ADDENDUM NO. 2

For the
**CHAUTAUQUA AUDITORIUM
FIRE SUPPRESSION SYSTEM**
Waxahachie, Texas

AD2-01 Sheet E2.00 – Electrical Plan

4 ELECTRICAL PANEL DETAIL
SCALE: 1/8" = 1'-0"

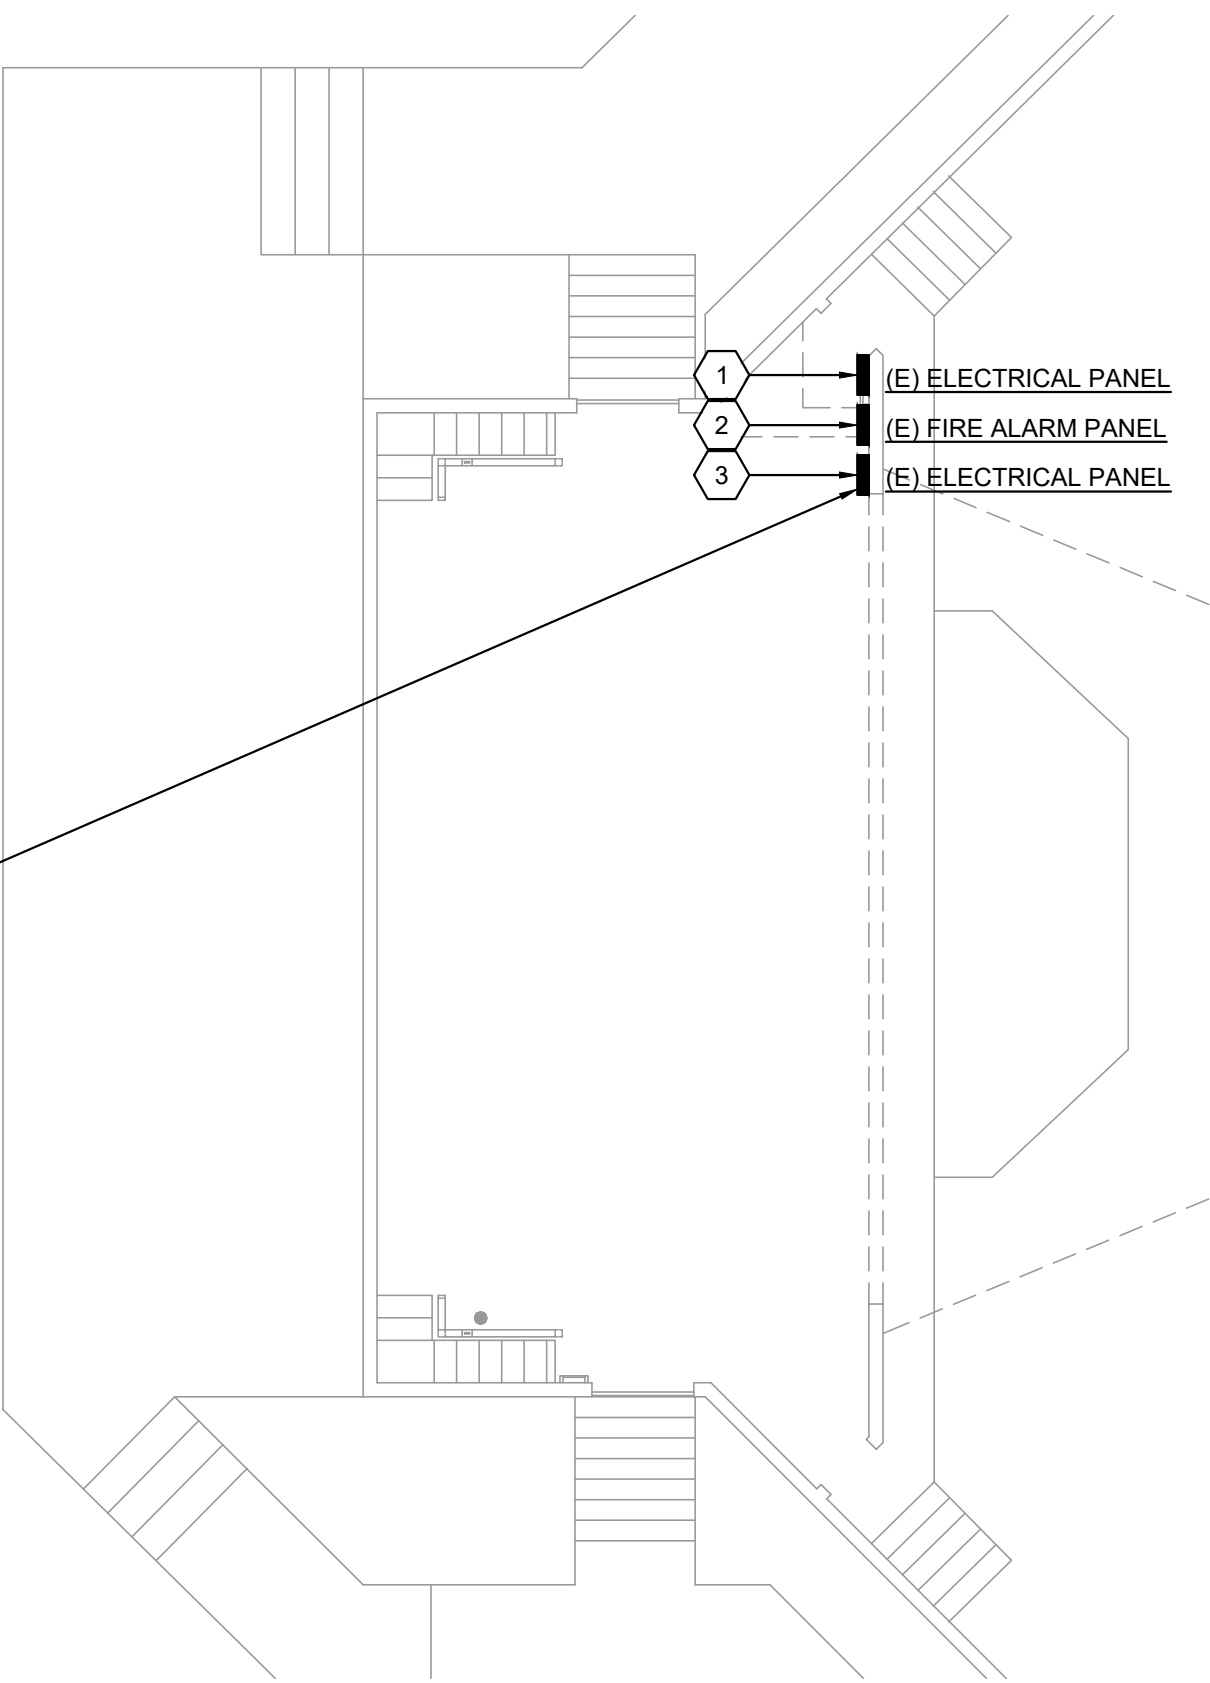
Replace sheet entirely, see attached. Photo of existing electrical panel on detail 4 was missing and has been added.
